PROBLEM SOLVER™ BULLETIN

BULLETIN: 27010

Premature Ball Joint Failure

2002-2005 Jeep Liberty

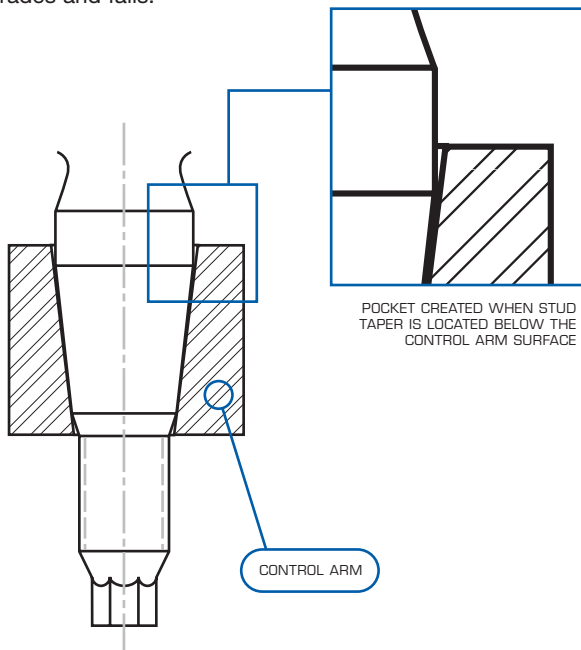
PROBLEM:

OE ball joint fails prematurely

Ball joint boot failures can cause corrosion, accelerated wear and possible joint separation. Failure can be traced to a slight gap between the ball joint stud and control arm. The gap or pocket accumulates moisture, promoting corrosion of the ball joint stud and control arm tapered hole. The corrosion generated by the pocket penetrates under the dust boot, wearing at the sealing surface of the boot. Once exposed to the elements, the sealed, non-serviceable ball joint quickly degrades and fails.
